Project	IEEE 802.16 Broadband Wireless Access Working Group < http://ieee802.org/16 >	
Title	Enhancements to UCP LBT	
Date Submitted	2007-09-11	
Source(s)	Paul Piggin NextWave Broadband Ken Stanwood NextWave Wireless Yair Bourlas NextWave Broadband Kathy Sohrabi NextWave Broadband	Voice: + 44 1249 800167 E-mail: ppiggin@nextwave.com Voice: +1 858 480 3327 E-mail: kstanwood@cygnuscom.com Voice: +1 858 480 3279 E-mail: ybourlas@nextwave.com Voice: +1 858 480 0549 E-mail: ksohrabi@nextwave.com
Re:	IEEE 80216-07/019 Task Group Review of P802.16h/D2c	
Abstract	Enhancement to UCP LBT based on simulation results and analysis	
Purpose	To address a handful of improvements to the LBT portion of the section 6.4 UCP.	
Notice	<i>This document does not represent the agreed views of the IEEE 802.16 Working Group or any of its subgroups. It represents only the views of the participants listed in the "Source(s)" field above. It is offered as a basis for discussion. It is not binding on the contributor(s), who reserve(s) the right to add, amend or withdraw material contained herein.</i>

Enhancements to UCP LBT

This document provides changes to IEEE P802.16h/D2b [1].

Figure h2—LBT - UL MAP Relevance N

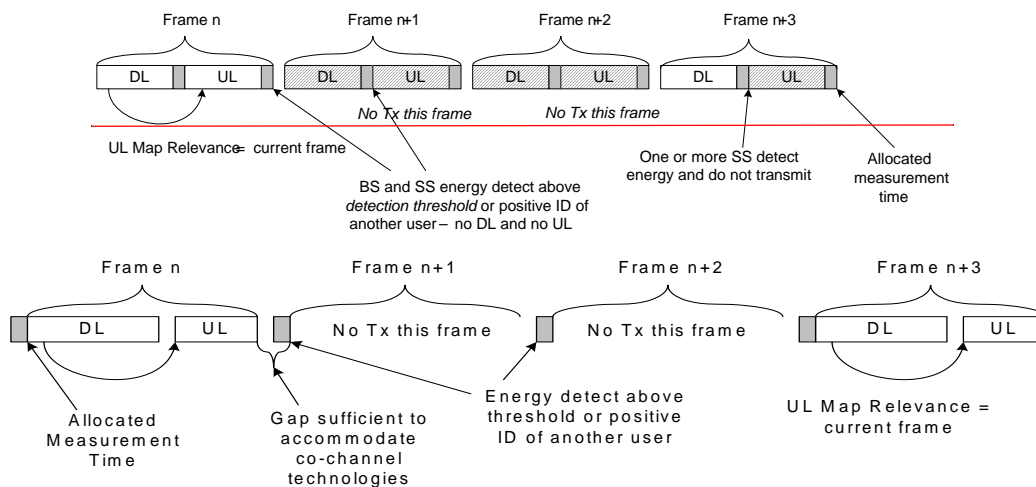
[Replace the following Figure.]

Figure h4—Reclaiming the Medium

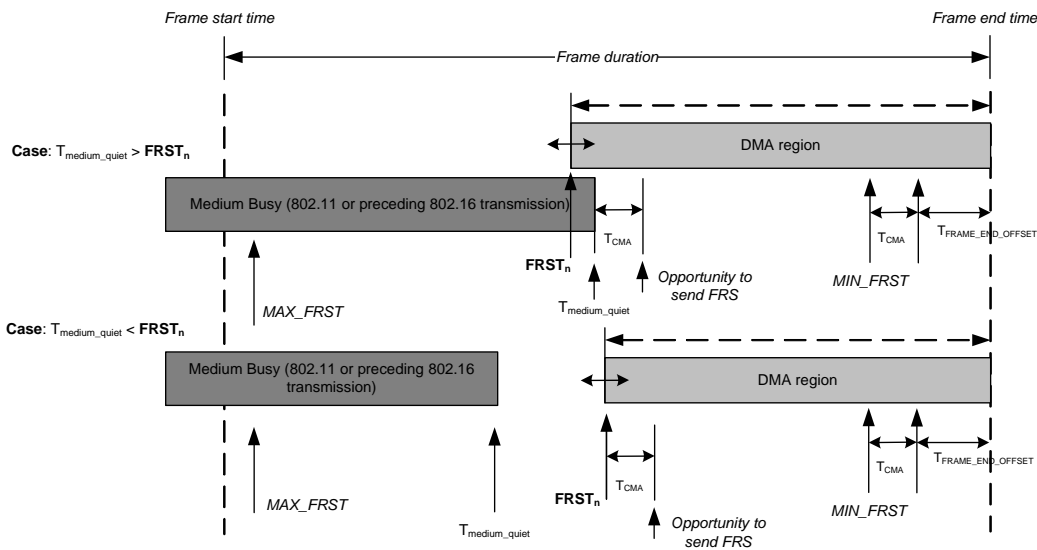
In cases of high traffic volume for both co-channel asynchronous and 802.16h systems, the synchronous nature of 802.16h systems disadvantage them relative to asynchronous systems. Generally, an asynchronous system will access the medium very soon after it has become free while an 802.16h system waits until the frame boundary (typically 5 ms) to reclaim the medium. The Dynamic Medium Access (DMA) protocol enables an 802.16h system to determine that it is not receiving its fair share of the channel occupancy relative to other co-channel systems and regain the medium.

If the BS's current utilization of the channel is less than its utilization goal, the BS exerts extra effort to reclaim the medium by assessing the channel conditions increasingly earlier before the start of the DL subframe up to a point in time, *MINFRST*, described below. When the BS detects the medium is available, it transmits an FRS to claim the downlink subframe. The protocol has the following terms and equations:

The parameters are applied as shown in Figure h 4.

Figure h5—BS Dynamic Medium Access Protocol

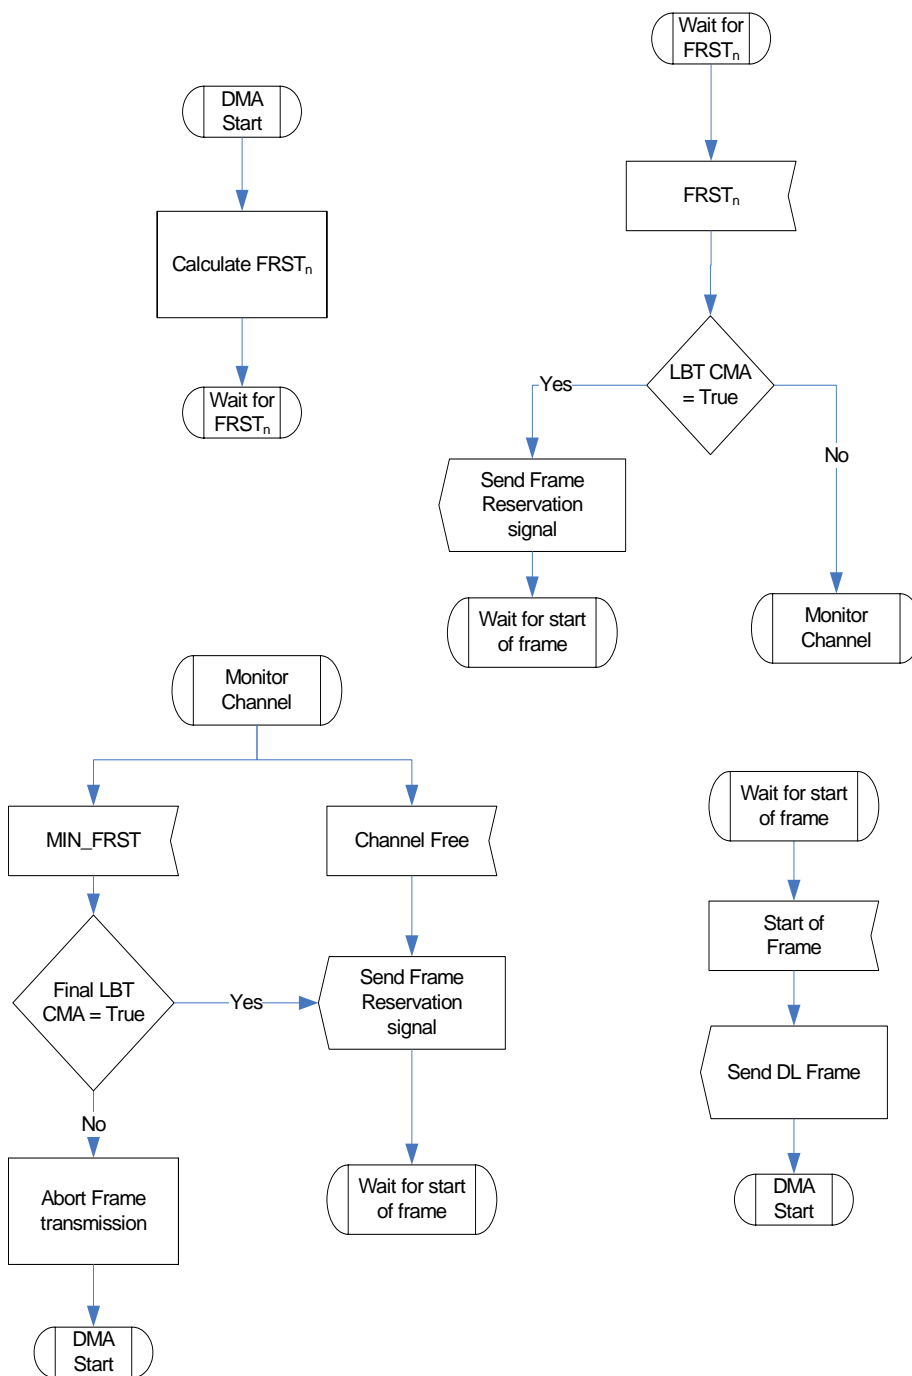
The BS SDL for the DMA protocol for reclaiming the medium is shown in Figure h 5.

Figure h6—UL FRS

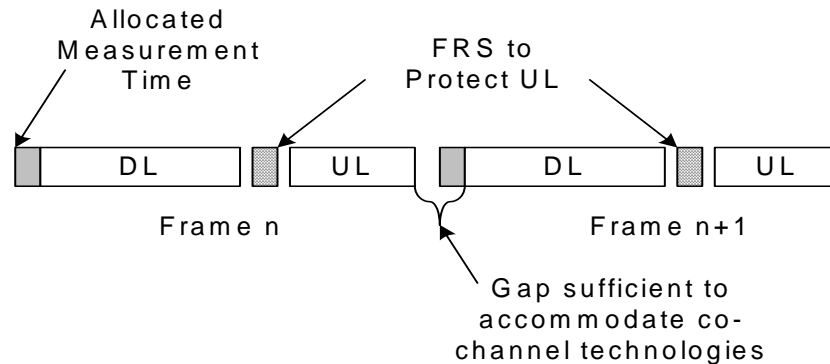
When using any carrier sense protocol, such as LBT, in a wireless environment the hidden node problem cannot be 100% avoided. It can only be mitigated. Additionally, in bands such as 3.65 GHz in the US, there is an aggravated hidden node problem due to the distinctly lower transmit power allowed for mobile devices compared to fixed, registered devices. The mobiles are more often geographically disadvantaged due to this transmit power disparity. Fixed, registered client devices can also be geographically disadvantaged (the classical hidden node problem), although not as often. To remedy this the BS transmits a Frame Reservation Signal (FRS) at the end of the DL subframe to reserve

the subsequent UL subframe (or used portion, thereof) for the subscriber stations. The form of the FRS is band dependent and should be structured to be receivable by other technologies that may be co-channel. For instance, in bands where 802.11 would be a typical co-channel asynchronous system, the 802.11 CTS transmitted using the appropriate 802.11 burst structure would suffice. The reservation of the UL subframe by the BTS precludes the need for the SS to also perform LBT. The use of the FRS to protect the UL is shown in Figure h 6.
